### RESOLUTION HOLDING HEARING ON REQUEST FROM HDR LAND DEVELOPMENT, LLC TO REZONE PROPERTY IN THE VICINITY OF 4896 EASTON BOULEVARD

### HDR Land Development, LLC, Vicinity of 4896 Easton Boulevard

## STAFF REPORT TO THE PLANNING COMMISSION

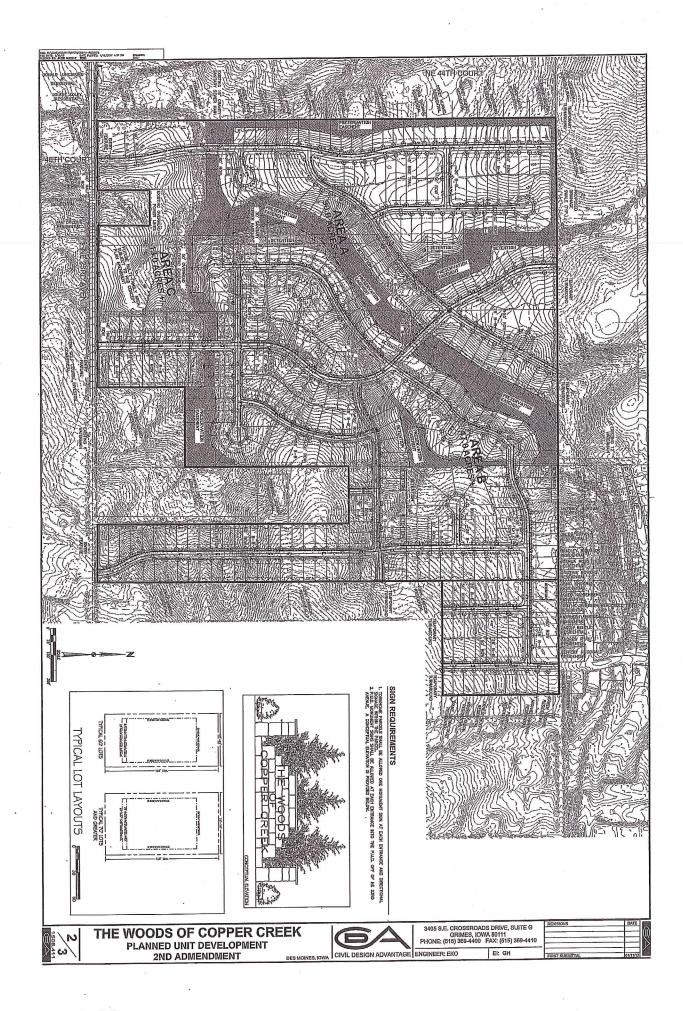
Looking at the proposed plans, it becomes apparent that minimal planning has been invested in the 2<sup>nd</sup> amendment. The proposed Andrews Place is virtually a straight street without any character compared to the existing Woods of Copper Creek PUD. Further, the stretch from NE 23<sup>rd</sup> to the first cross street is nearly double the length of any roads in the existing Woods of Copper Creek PUD and any newer development in the surrounding area. This will truly be used as an access road; a straight shot through a residential area with minimal design to slow traffic.

The lack of planning for the 2<sup>nd</sup> amendment will also limit design options to the east between Andrews Place and NE 51<sup>st</sup> Ct, should that land be developed in the future. The choice is limited to extending Brook View Dr, and the unnamed street to the west, straight south to connect with NE 23<sup>rd</sup>. These streets will similarly lack character and be used as through streets with little in place to slow traffic.

Finally, a point that in and of itself is reason enough to deny the amendment as proposed, watershed management. In the neighborhood meeting referenced above, the representative stated that all water flow will be in the direction from the northeast to the southwest and that it would be managed independent of the surrounding Brook Run development. With a simple physical visit to the northeast portion of the proposed amendment one quickly sees that there is a sizable hill when looking south. I don't believe water will flow up hills, which further calls into question the thoroughness of planning put forth in the proposal. Brook Run has, and continues to have, severe water issues. Many on the north side of Stream Side Cir lost portions of their back yard, some upwards of 20 feet, and incurred substantial cost due to erosion caused by unplanned water volumes within the development. Adding additional water into this system that is already over capacity and damaged cannot be allowed.
